SUBJECT: PLANS AND PROPOSAL ADDENDUMS
PROJECT: STP 2023 (675)MM CONTROL: 1433-02-044
COUNTY: COMAL
LETTING: 05/04/2023
REFERENCE NO: 0419

PROPOSAL ADDENDUMS

DESCRIPTION OF ABOVE CHANGES
(INCLUDING PLANS SHEET CHANGES)

531-6010	CURB RAMPS (TY 7)	EA 0
531-6013	CURB RAMPS (TY 10)	EA 0

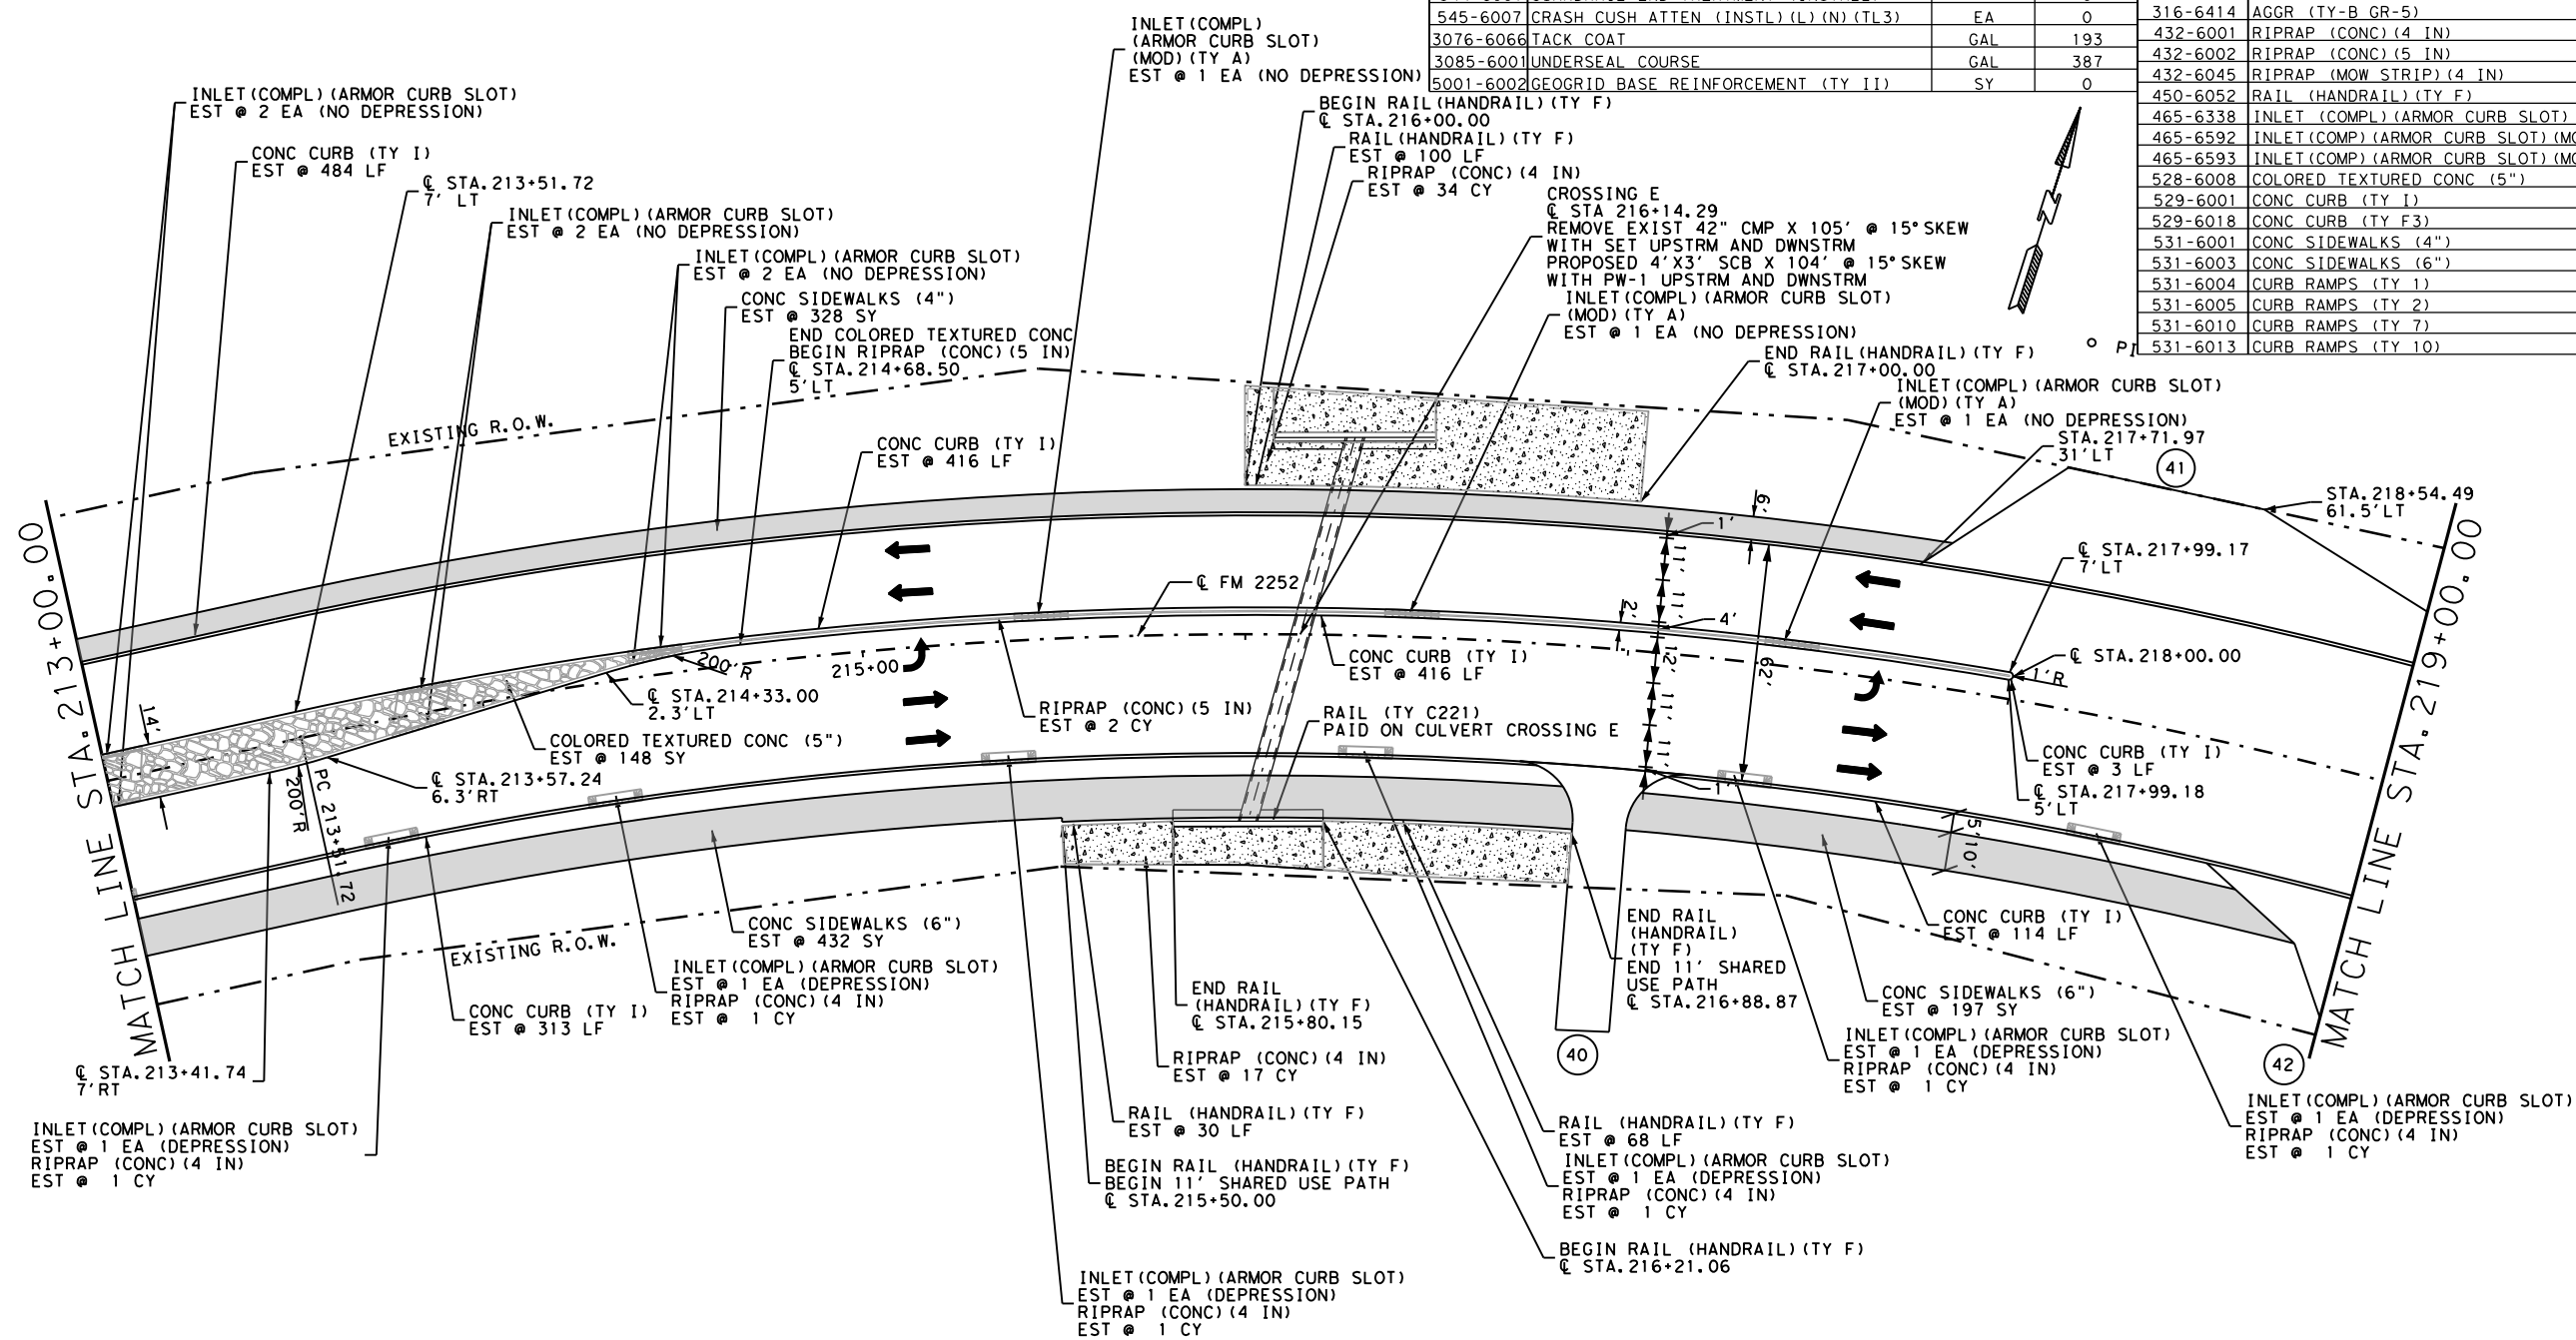
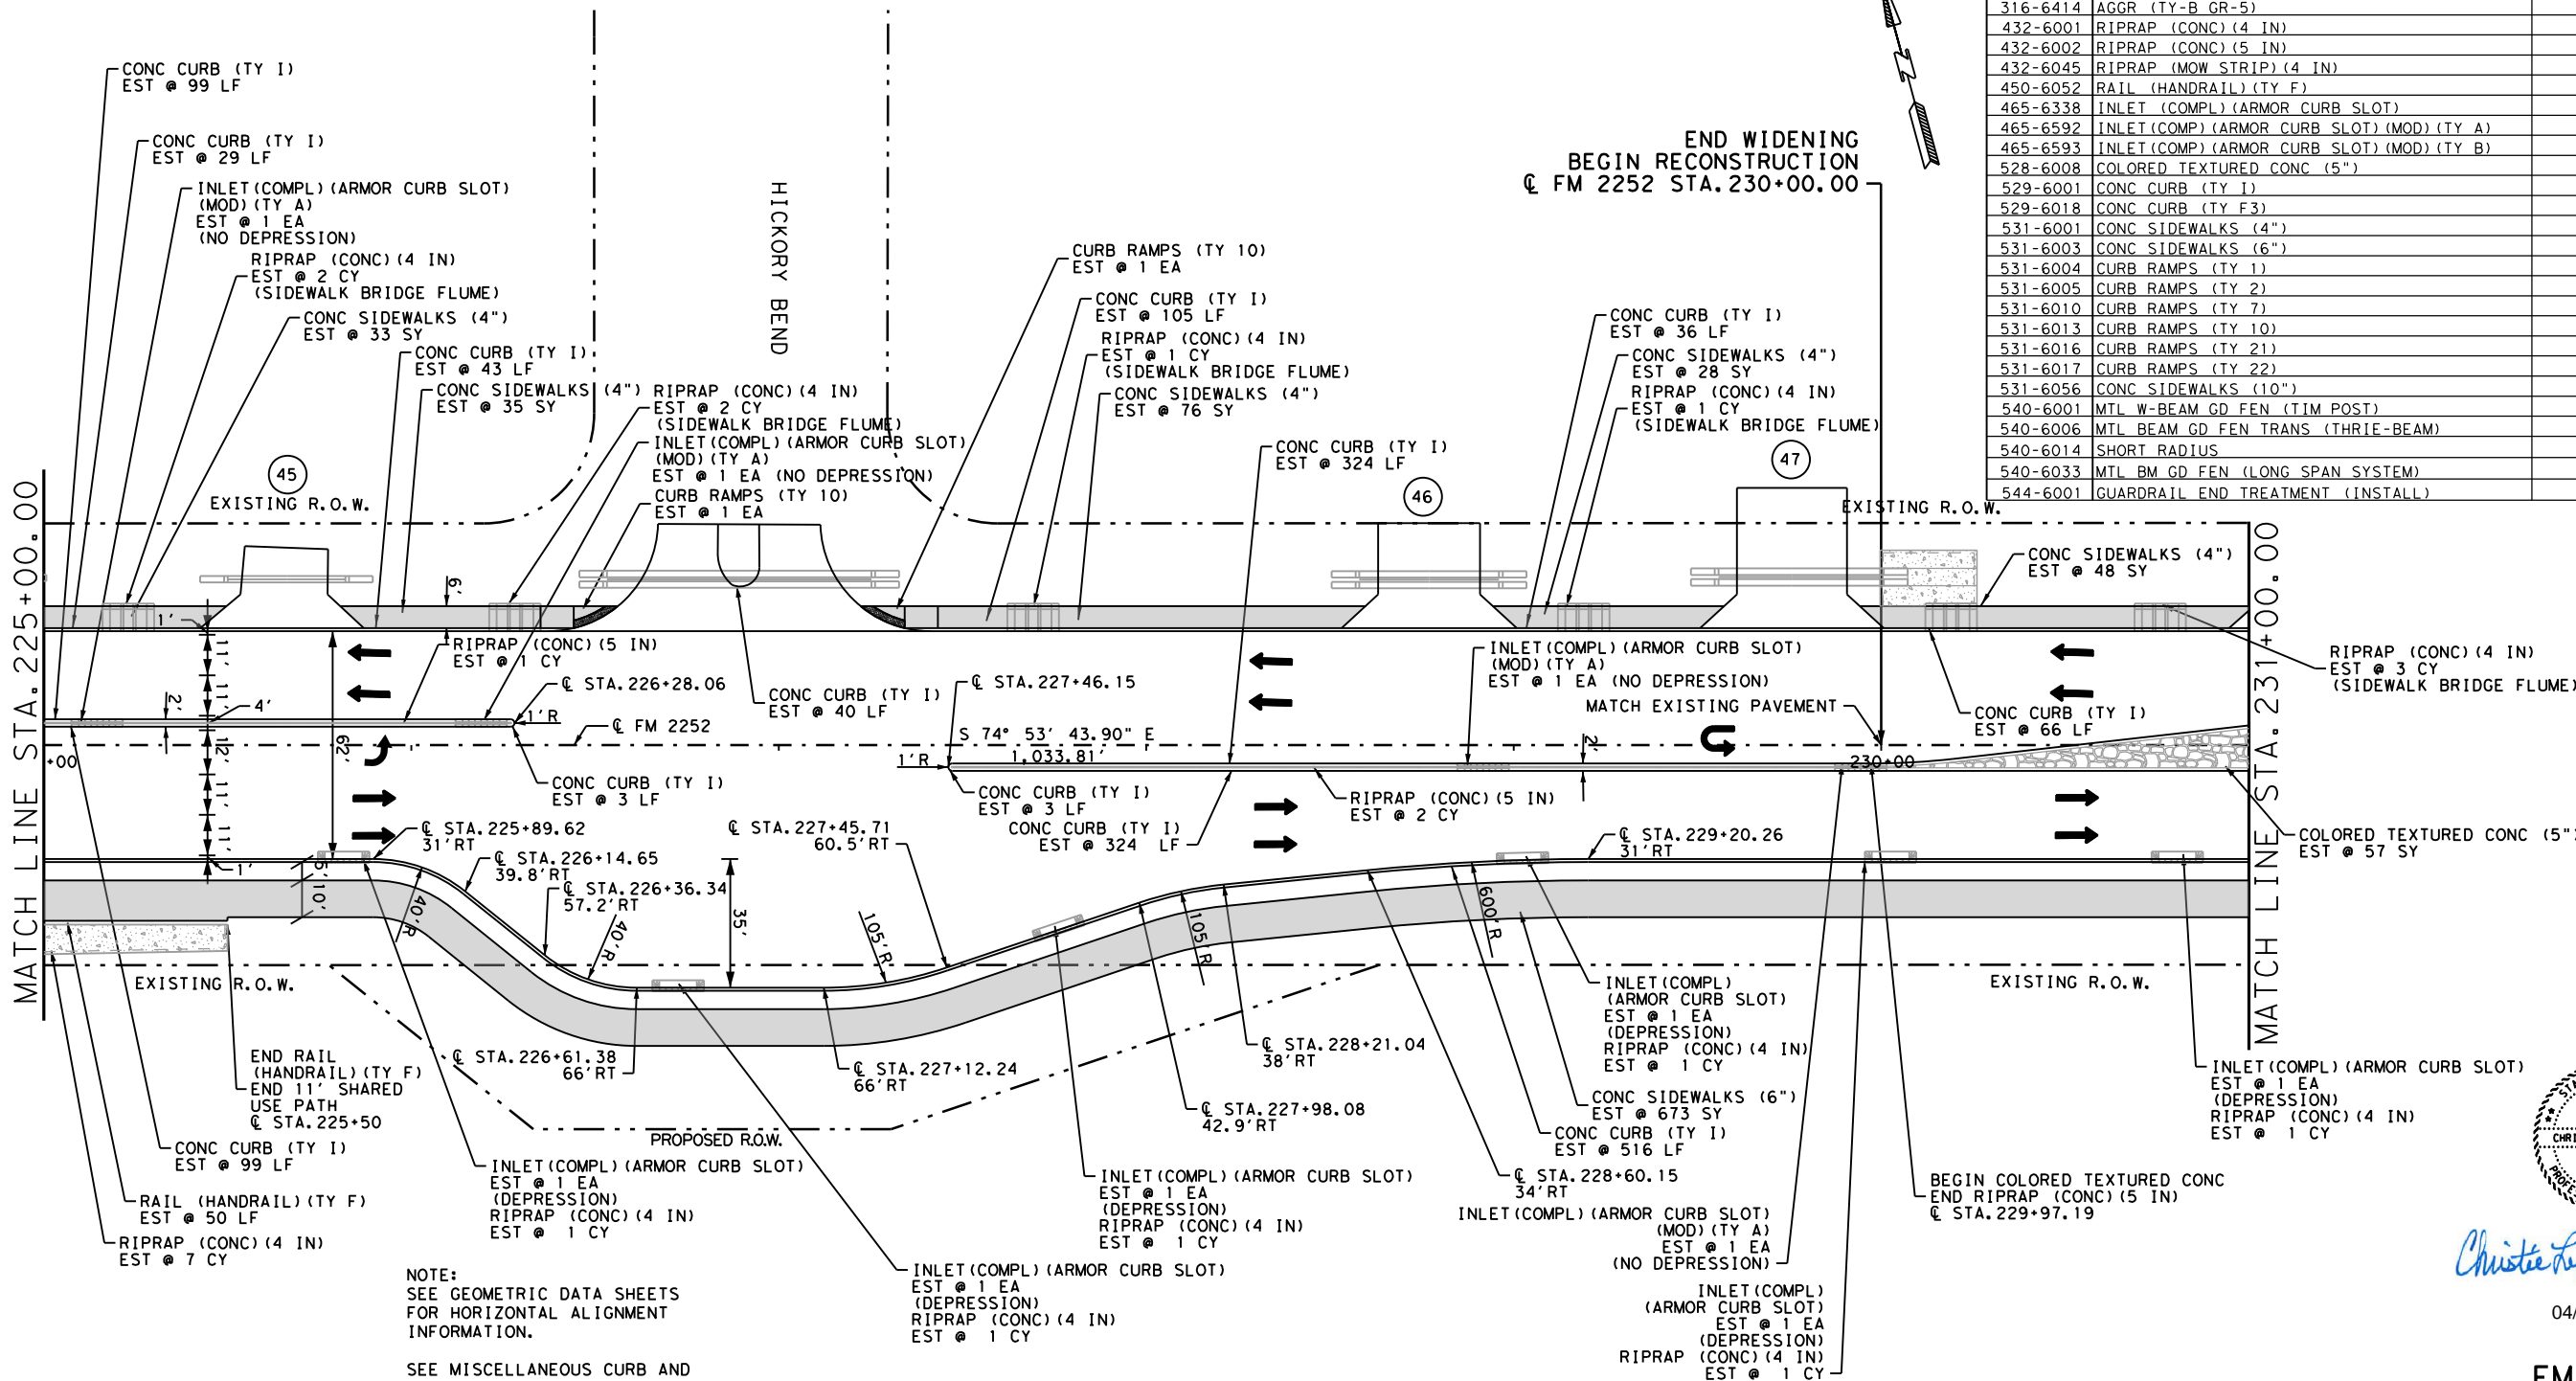
SHEETS 413-449: REPLACED ITEM NO. 545-6017 WITH ITEM NO. 545-6007
